POLICY REPORT  
DEVELOPMENT AND BUILDING

Report Date: September 5, 2017  
Contact: Susan Haid  
Contact No.: 604.871.6431  
RTS No.: 12183  
VanRIMS No.: 08-2000-20  
Meeting Date: October 17, 2017

TO: Vancouver City Council  
FROM: General Manager of Planning, Urban Design and Sustainability  
SUBJECT: CD-1 Rezoning: 5110 Cambie Street

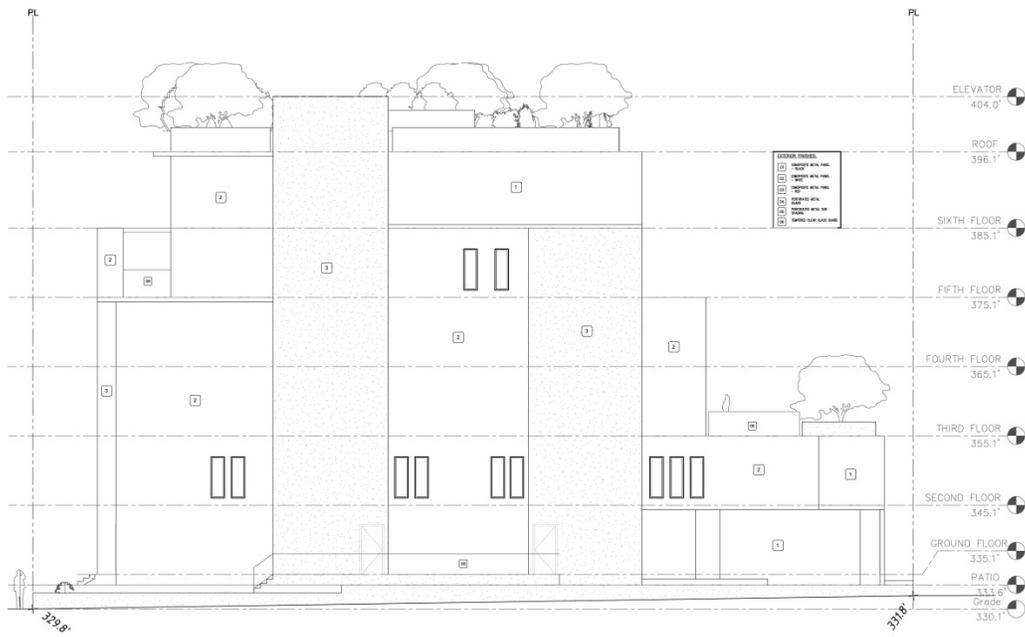
The design lacks a clear approach to sustainability, as it has extensive glazing and thermal bridging, and the solar shading does not wrap the corner to the west elevation. One panel member recommended exploring rainwater infrastructure.

The Panel noted that the mini-park needs design development and the ramp should be reconfigured. They mused that the mini-park could be like an art piece that contributes to the public realm. The raised patios along 35th are supported by the panel. They create a good separation between the public and private realms.

The parking ramp off the lane is a challenge but is supported. The panel suggested that perhaps parking access could be shared with the adjacent development to the south, so that the ramp could be removed.

**Applicant's Response:** The applicant thanked the panel and acknowledged that the design is a work in progress, and said that he will work towards a bold but more residential project.
